Vanguard 7300 Series Hardware Advisory Notice T1/E1/PRI Card Release 6.5.T10A

Vanguard 7300 T1/E1/PRI Card Upgrade

Figure 1: Revision Identifier Label

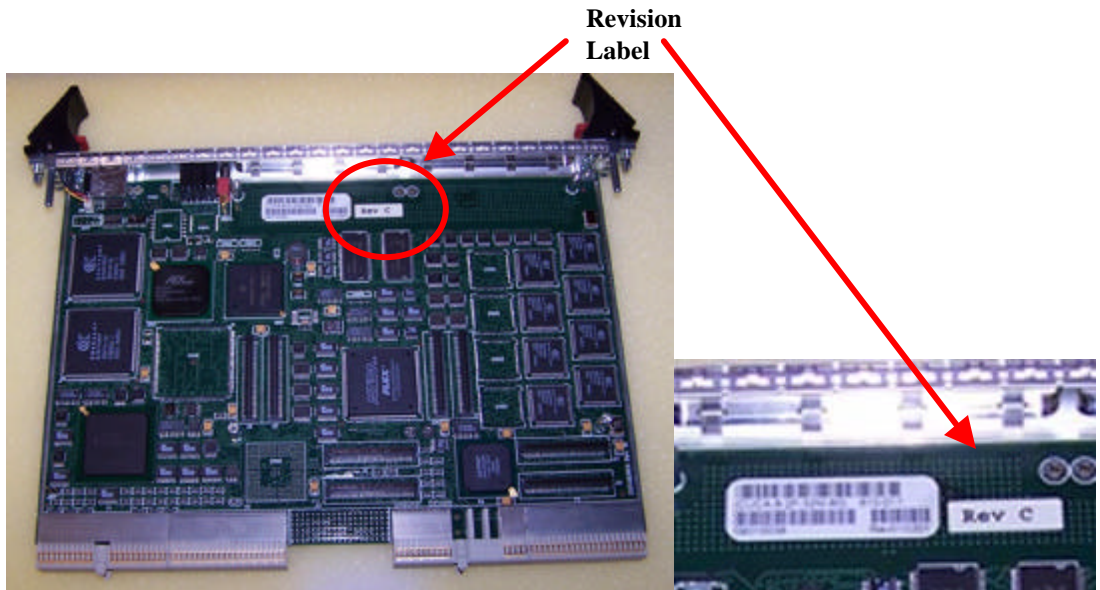
The arrows in Figure 1 show the location of the revision label, which identifies whether the T1/E1/PRI card is Revision C.

The Vanguard 7300 T1/E1/PRI upgrade is designed to improve product performance. The upgrade requires a software enhancement and applies *only* if you have a Revision C T1/E1/PRI card.
